Whitfield Russell Associates Report on the NFAT for the MMF

Whitfield Russell Associates
May 13, 2014

Export Revenues Will Not Fully Recover Costs of New Hydro

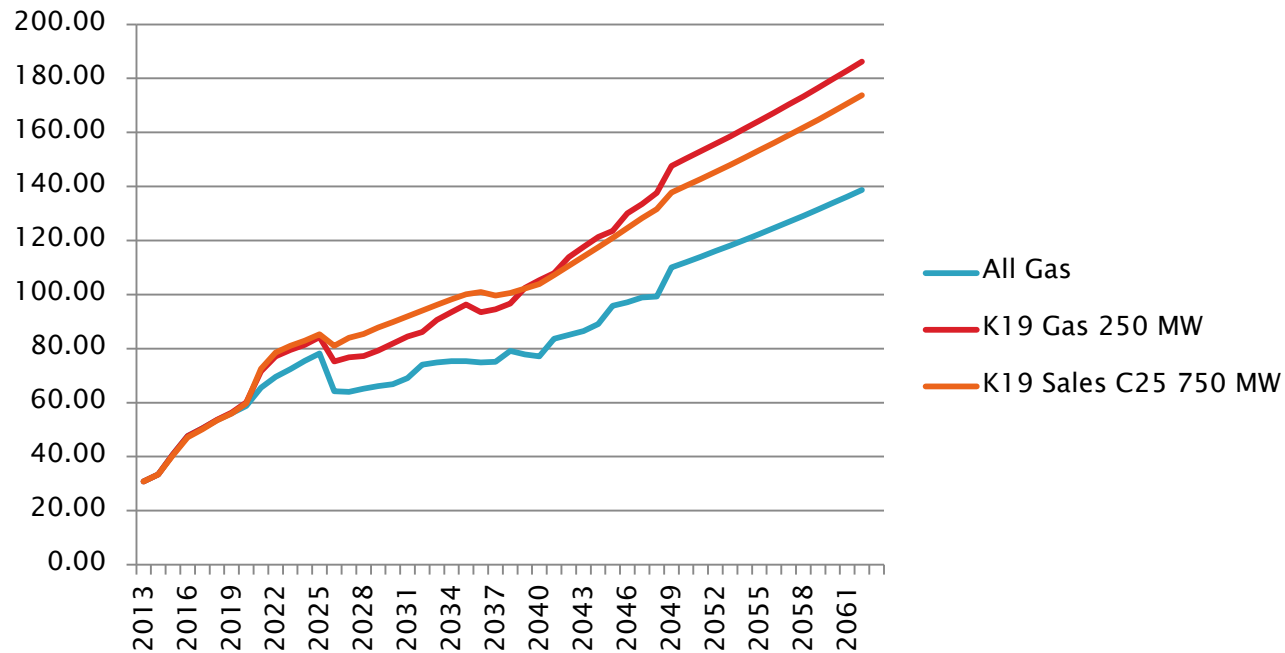
There is a substantial gap between:

- The high initial in-service annual revenue requirement to recover the cost of power for Wuskwatim, Keeyask and Conawapa (approximately \$100/MWH or 10¢/kWh – See BO 5/12 at 8, 54) and
- The much lower prices at which MH can expect to sell its firm and surplus hydro power in export markets (resulting in unit sales prices of no more than 6–7¢/kWh on average for firm sales and opportunity sales combined – See BO 5/12 at 55).

Impact of Prices and Study Length

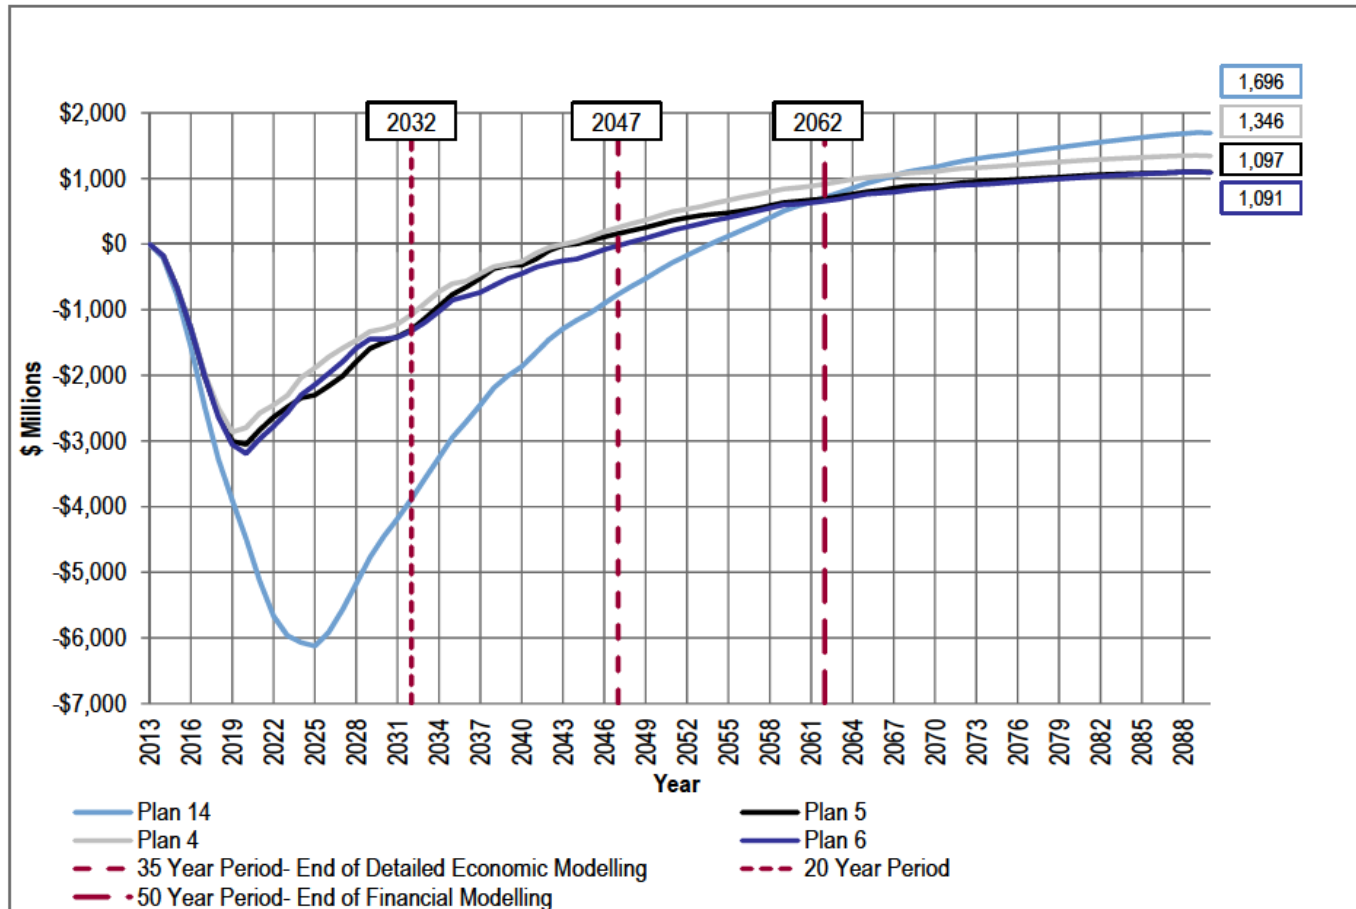
MH has an incentive to maximize firm exports and lock in pricing for firm exports, but is constrained by buyer resistance and the cost of alternatives. As costs escalate and forecasts of export prices fall, the point in time at which export revenues recover increased costs is pushed farther into the future. This set of constraints has provided a powerful incentive to lengthen the study period.

Erosion of Benefits Impacts Plan Choice

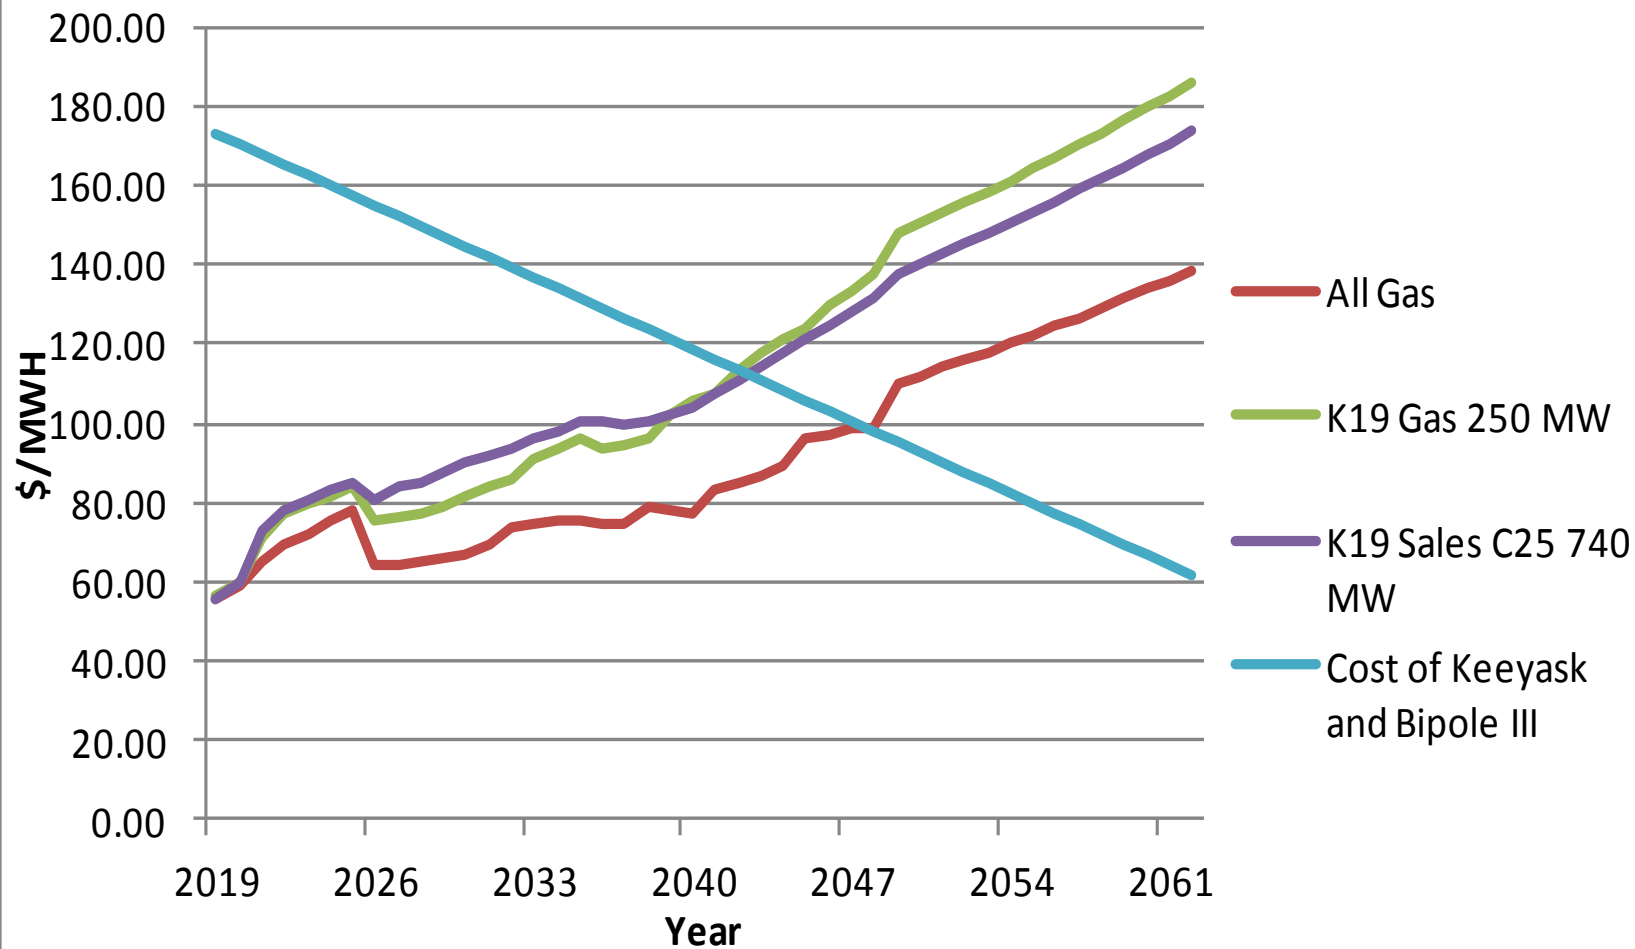
- ▶ Favorable economics of hydro erode as capital costs increase, as has been demonstrated in the updated work of MH. The initial \$1.696 Billion advantage enjoyed by the Preferred Development Plan (PDP) over the All-Gas Plan diminished to \$374 million as a result of an \$800 million increase in estimates of capital costs associated with Keeyask and Conawapa and the removal of the WPS investment decision (See MH Exhibit 95 at slide 123).
- ▶ With the addition of DSM at level 2, the PDP's NPV advantage over the All Gas Plan falls to only \$45 million (MH Exh. 95 at slide 130).

Figure 3-26: Annual resource generation mix in LCA No New Generation Plan

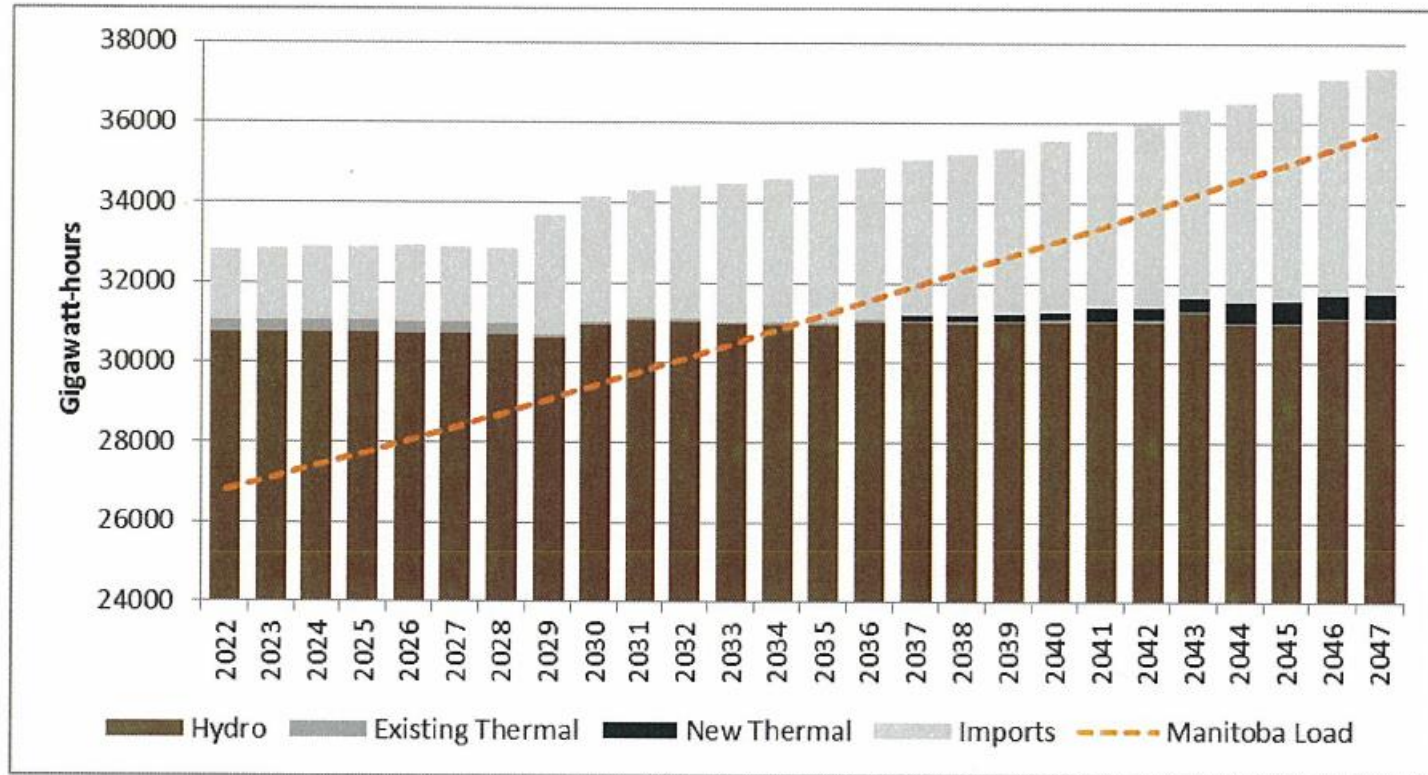
- ▶ This figure indicates that adding a 750 MW line between MH and MISO along with MH's purchasing firm power from generators in the U.S. (but not constructing additional generation in Manitoba) would enable MH to export substantially more power in the annual amounts shown above the dotted line. See the sentence at bottom of first paragraph: "There is also an increase in exports, which is the difference between the load line and the top of the resource mix bar."

- ▶ The final paragraph on the page states in part: "More [transmission] import capacity could allow higher imports in off-peak periods allowing exports of hydro during peak price periods. The value of these exports and of the additional capacity in this scenario is likely to be significant, but at this point is unknown, as that analysis has not been conducted by MH."

- ▶ This indicates that much of the increase in exportable energy in Plan 17 is the result of energy imported in off-peak hours and stored as elevated water in Manitoba reservoirs until needed as a source of firm capacity and energy for on-peak exports.

FIGURE 1: POWER SURPLUS/DEFICIT FOLLOWING LOSS OF BP I/II AT WINTER PEAK.

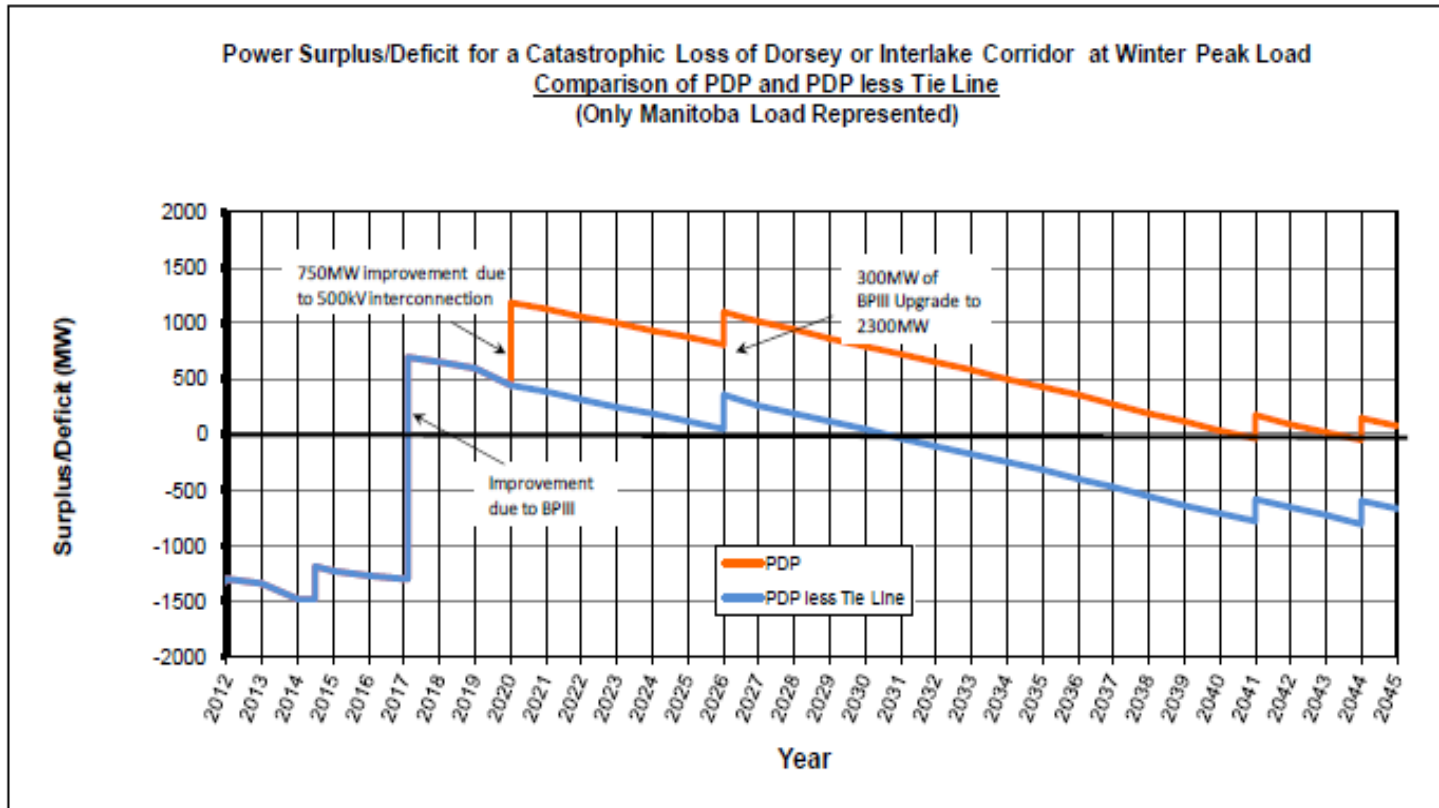
- ▶ This chart shows that an interconnection to the U.S. provides reliability benefits that are like those provided by Bipole III.
- ▶ The amount provided by the 750 MW 500 kV MMTP could have been increased, and built to a higher level [REDACTED]
